MNPS-3 EROLS

INSERTION INSTRUCTIONS FOR AMENDMENT 1

FIGURE 2.1-24
LAND USES WITHIN 10 km
MILLSTONE NUCLEAR POWER STATION
UNIT 3
ENVIRONMENTAL REPORT
OPERATING LICENSE STAGE

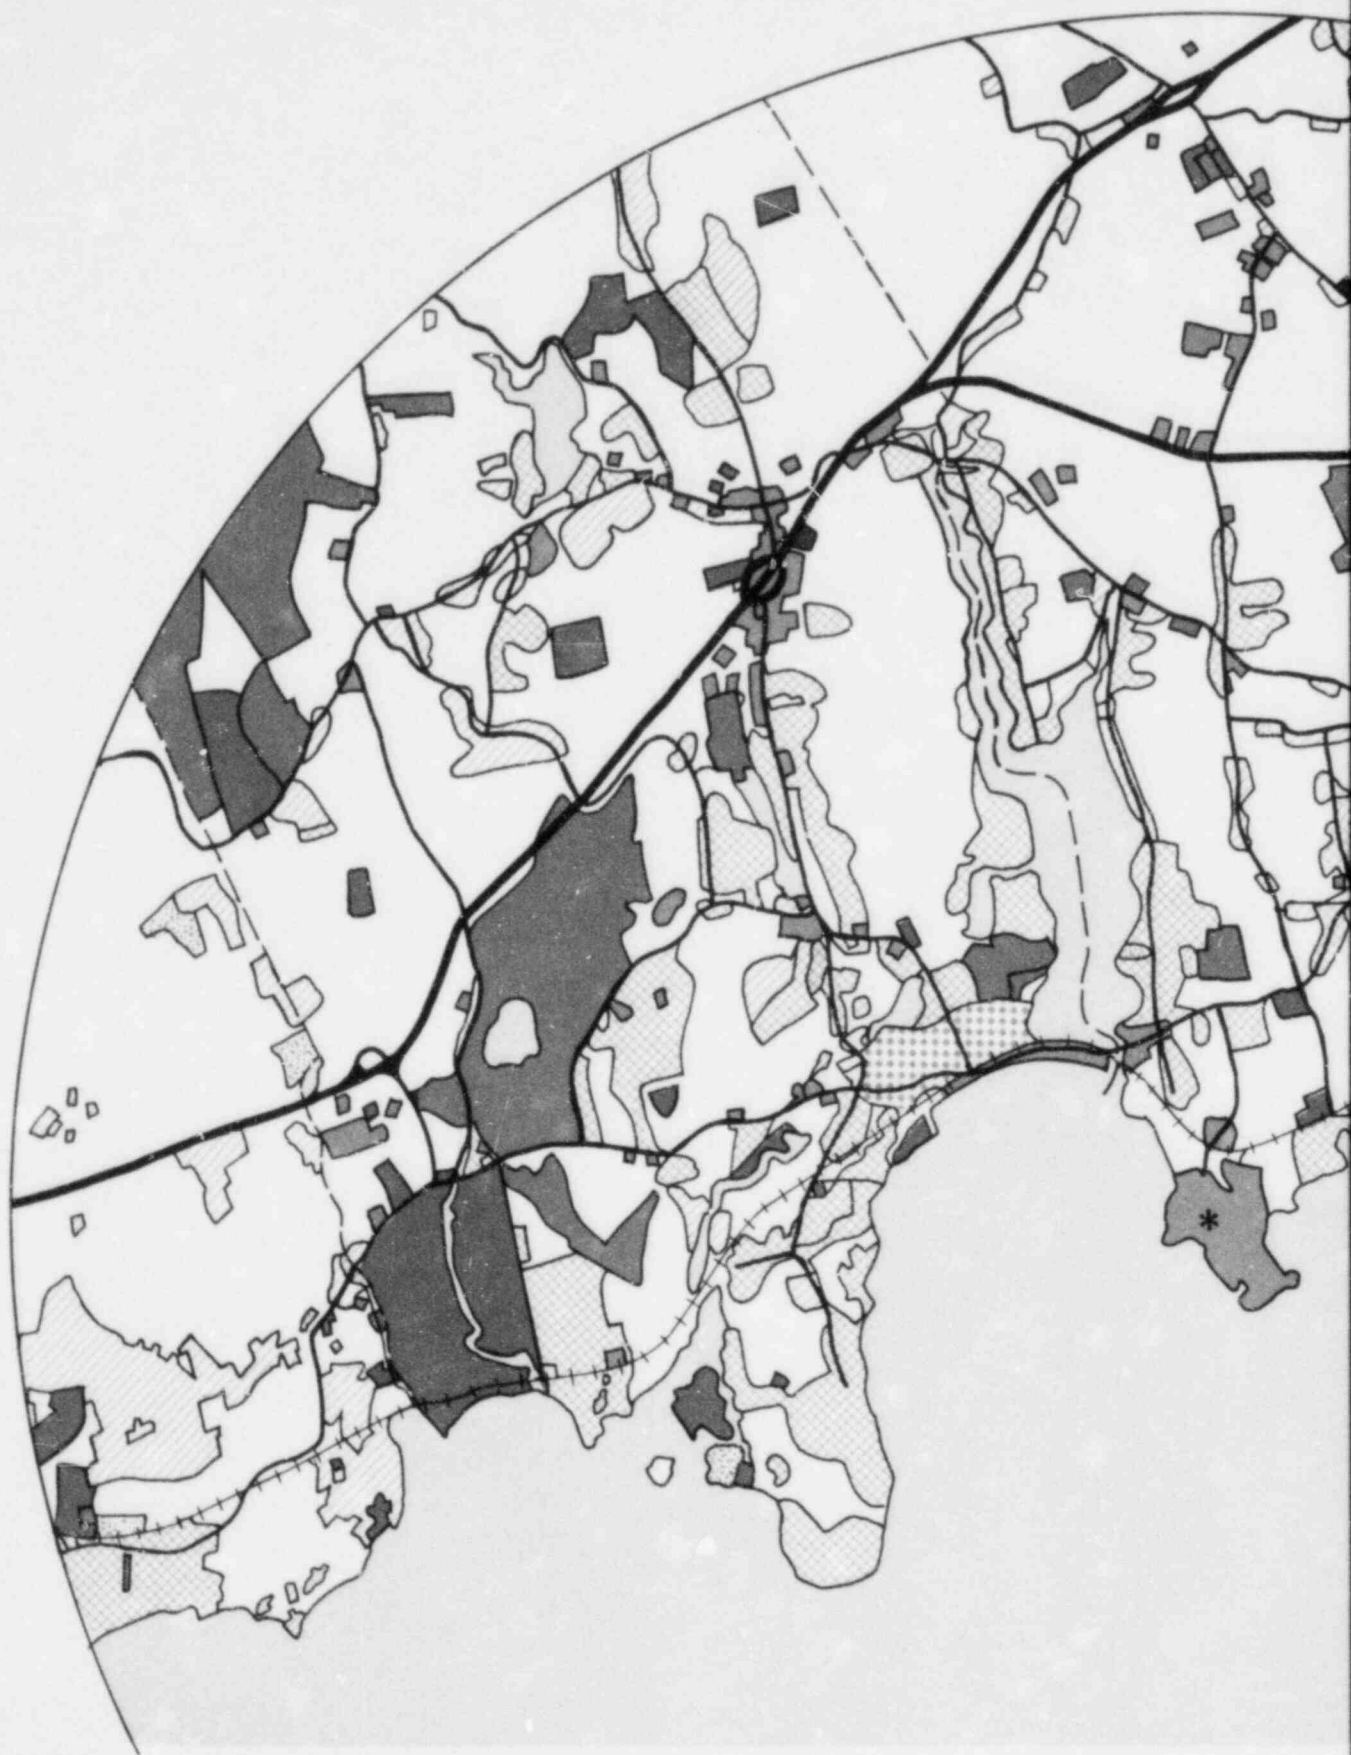
<u>Remove</u>	<u>Insert</u>	<u>Location</u>
2.1-7/8	2.1-7/8	S 2.1
2.1-11/12	2.1-11/12	
F2.1-24	F2.1-24
